**RESPONSE TO NRC QUESTIONS ON FORT CALHOUN'S
REFINED SEISMIC SPECTRA**

U.S. Nuclear Regulatory Commission

Omaha Public Power District

October 1990

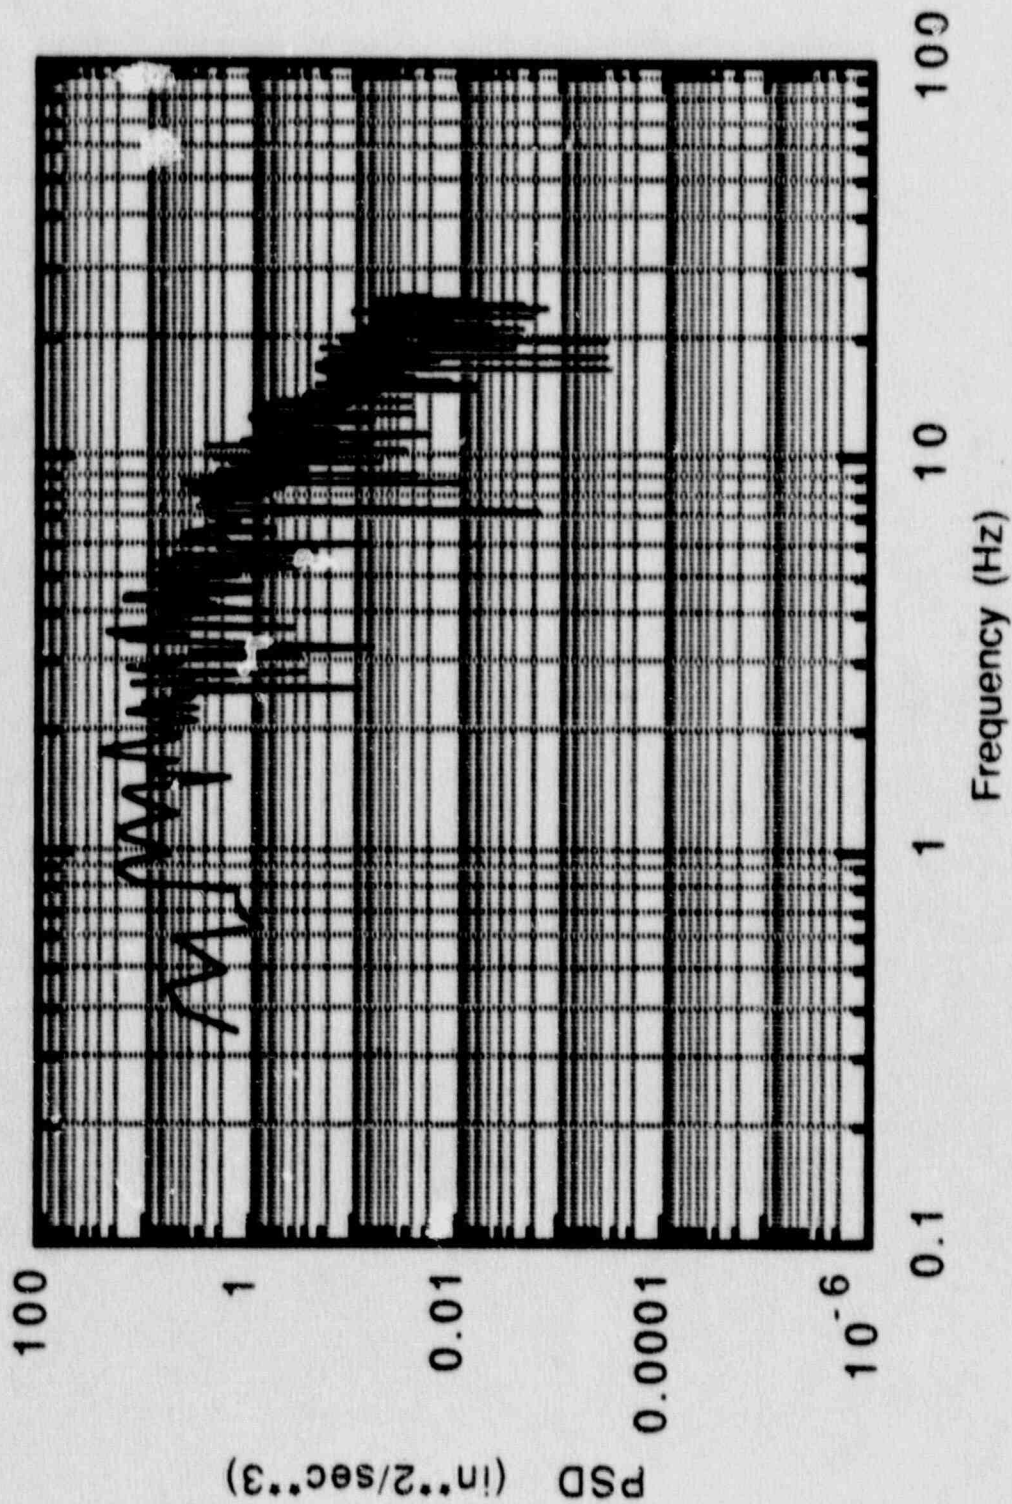
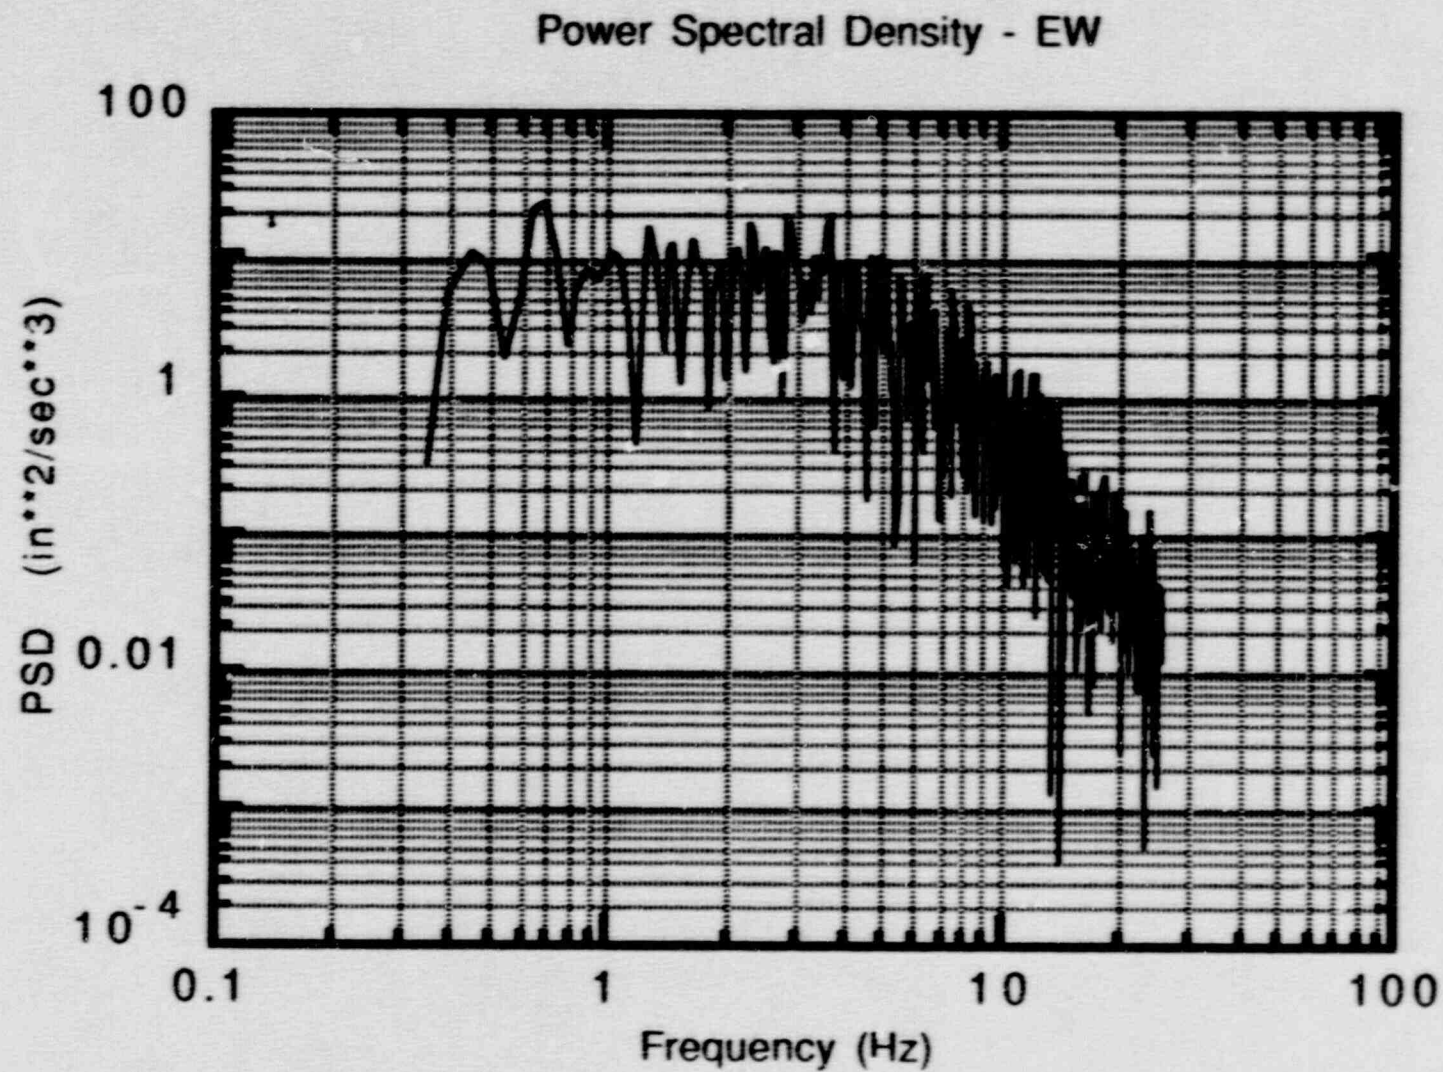
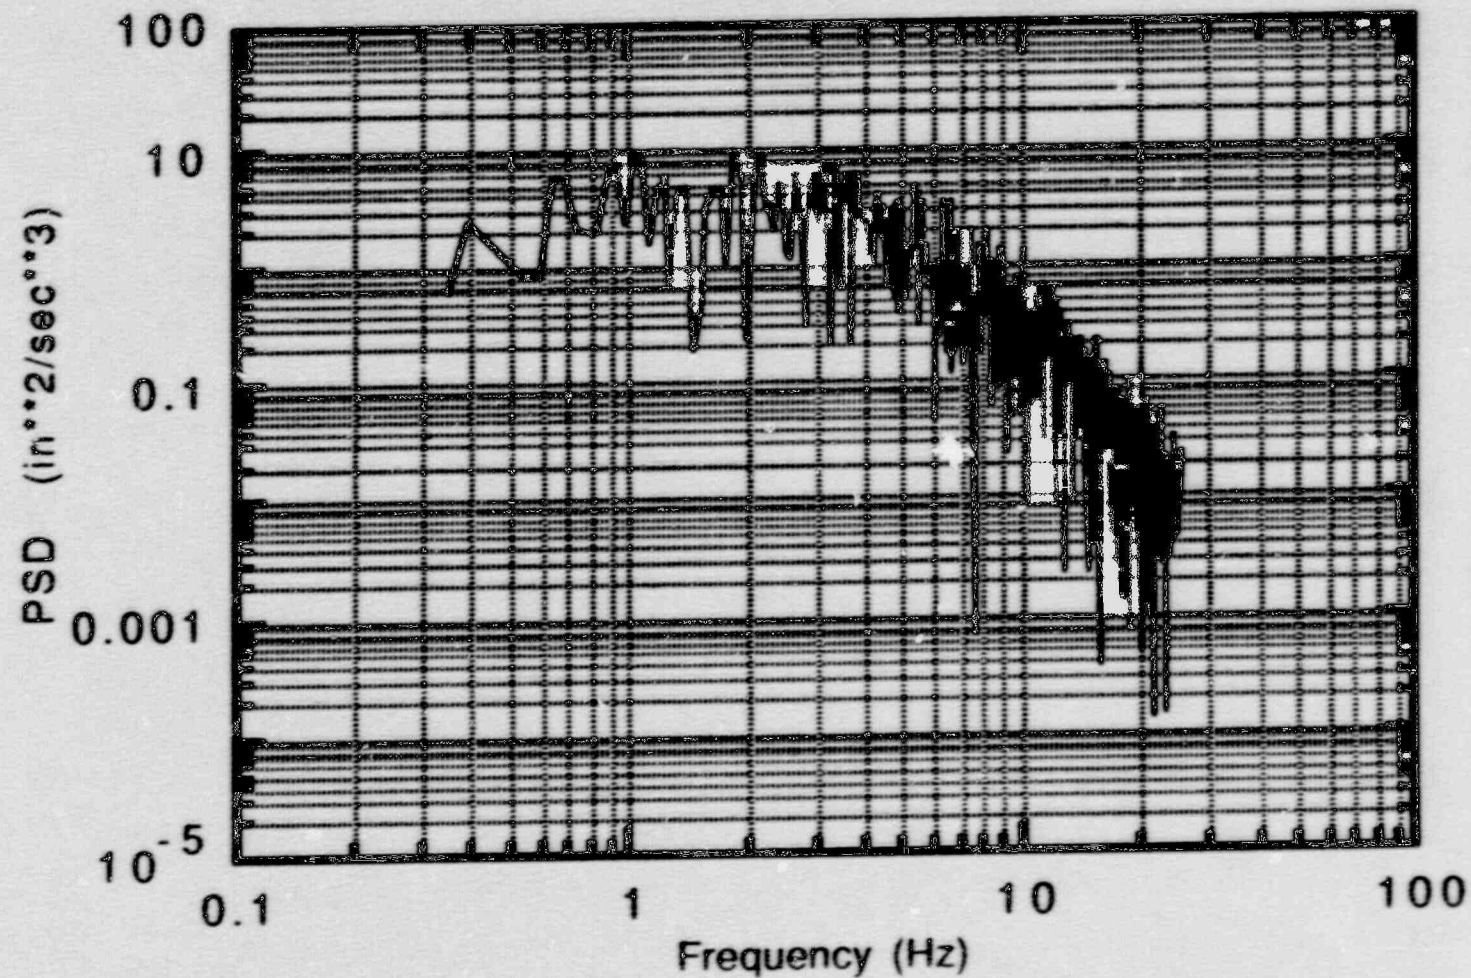
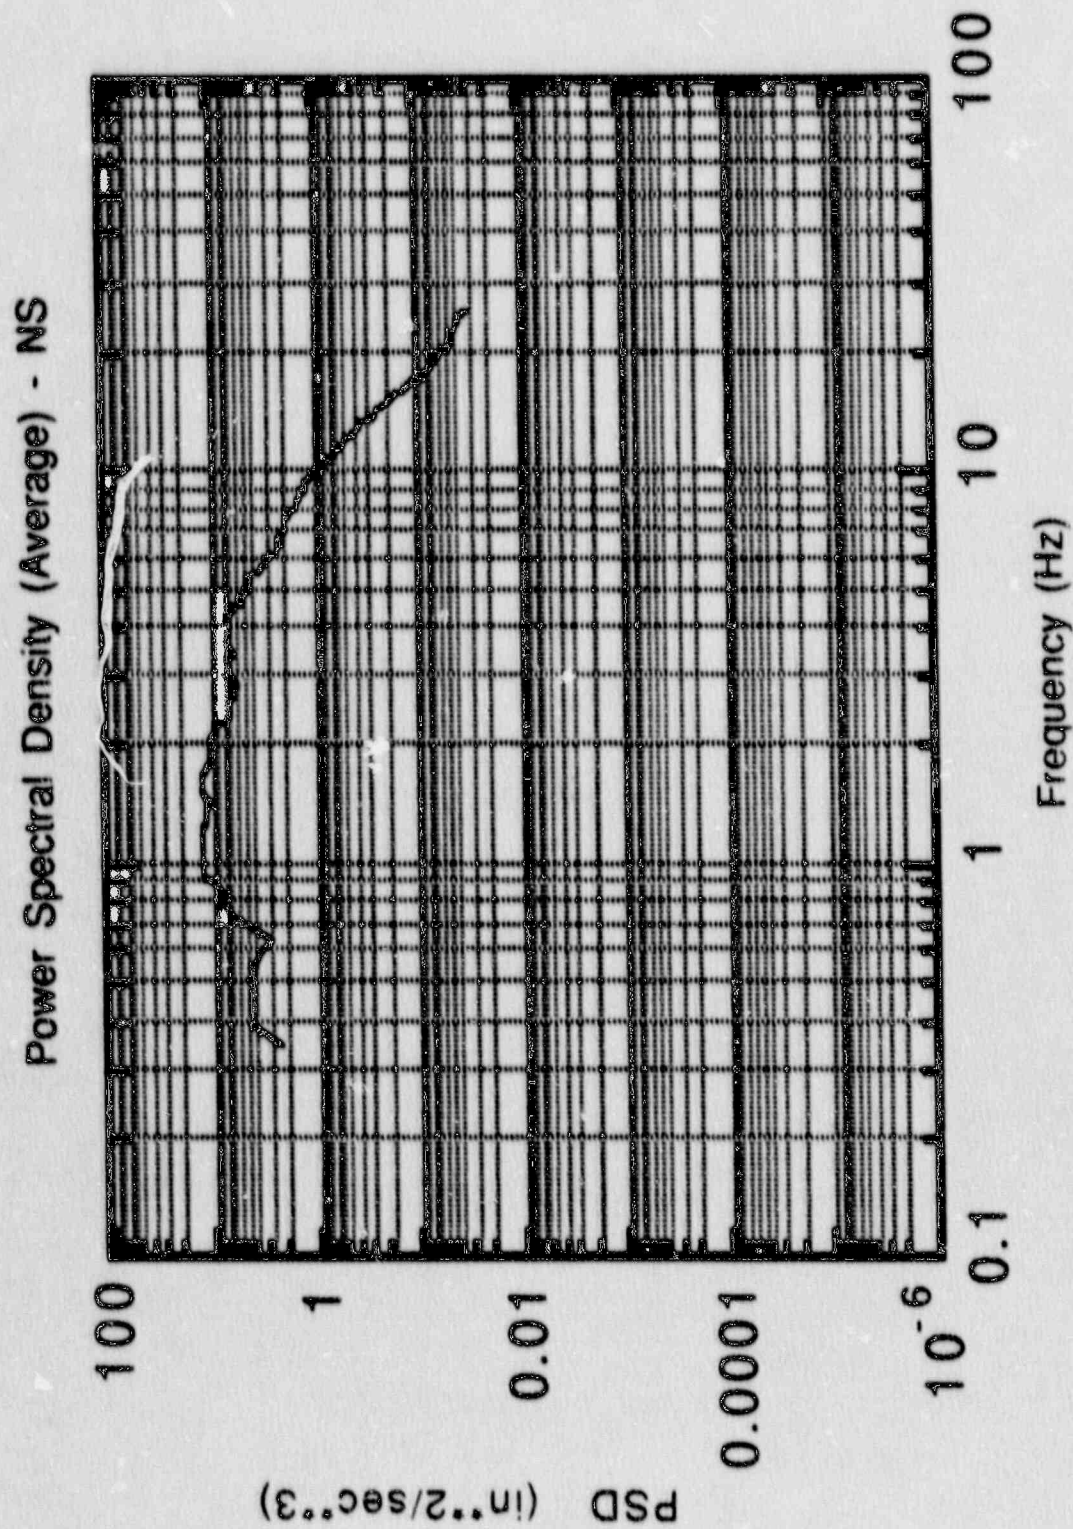
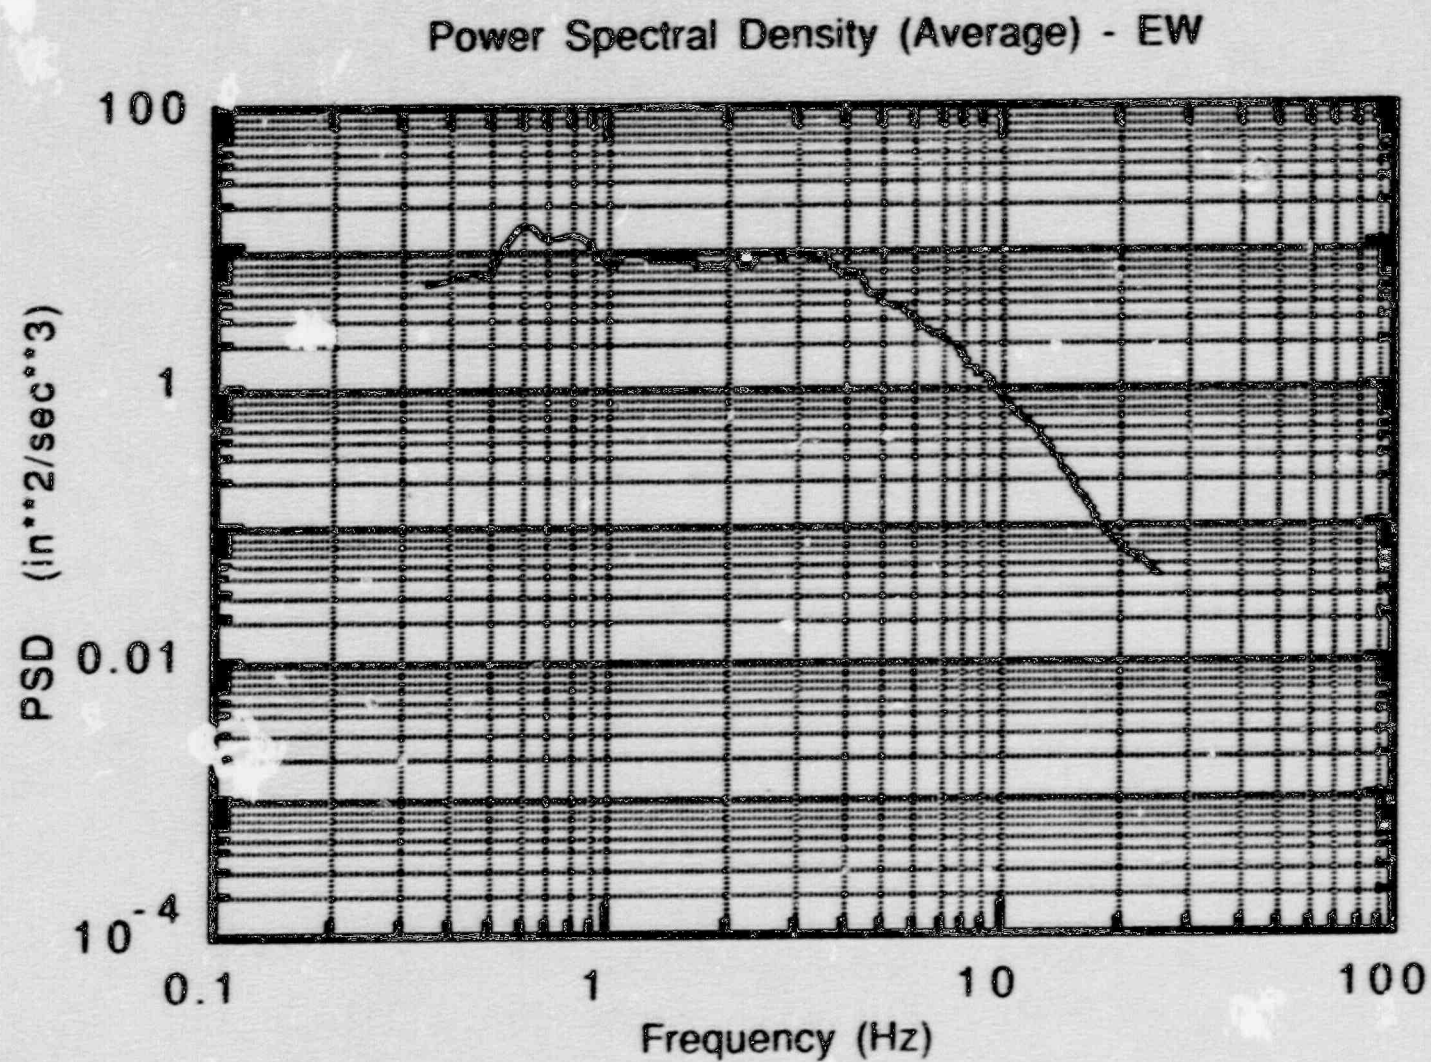
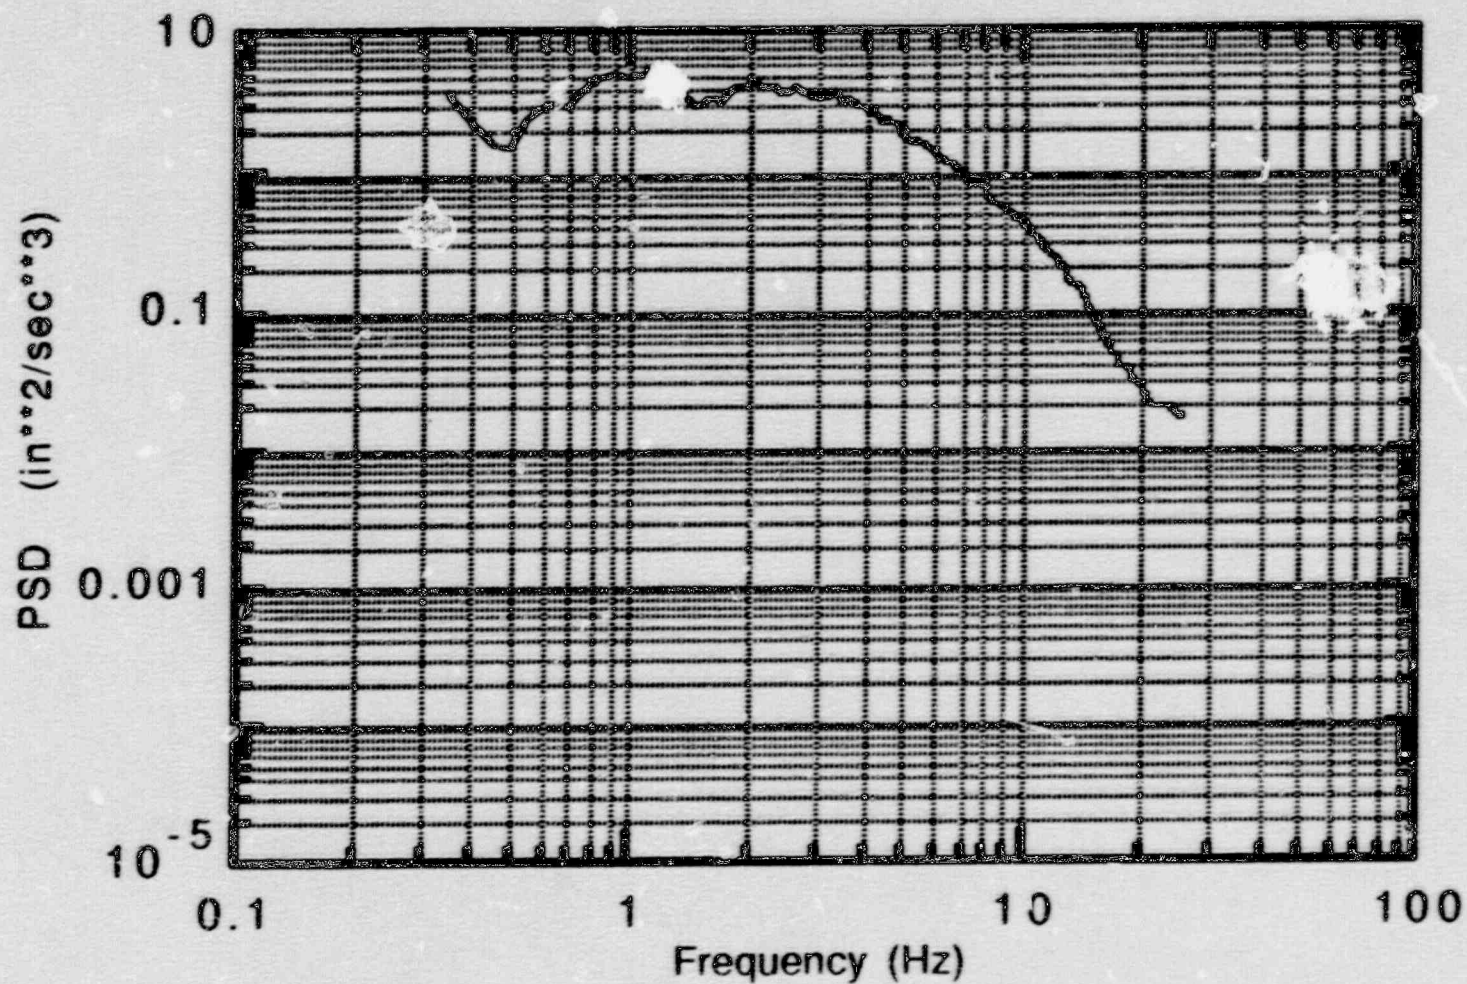
- (1) OI: (a) The Standard Review Plan (SRP) (NUREG-0800) recommends that the Power Spectral Density function (PSD) of an artificial time history used for single time history analysis meet a target PSD spectrum (NUREG/CR-3509).
- (b) The floor response spectra were calculated for a number of damping values ranging from 1 percent to 10 percent. To meet SRP requirements a check must be made that the response spectra of the artificial time history envelope the design response spectra for all damping values used in the response analysis.
- (c) The SRP recommends that the stationary phase strong motion duration of the artificial time history should be between 6 and 15 seconds.
- (2) RAI (a) Provide the information that the intent of the SRP recommendations are met.
- (b) Provide Impell's version of SIMQKE together with its user's manual.

- (c) The stationary phase strong motion duration of each of the three artificial time histories (NS, EW and vertical) is 8.0 seconds (Reference 4). This duration is in the range of 6 to 15 seconds, as recommended by the NRC in Reference 1.
- (2) RAI:
- (a) Pertinent information are provided in the responses to OI (a), (b) and (c) above.
 - (b) The User's Manual of Impell's SIMQKE computer program is provided in this package as Attachment 1. The source code of the program is included in the User's Manual.
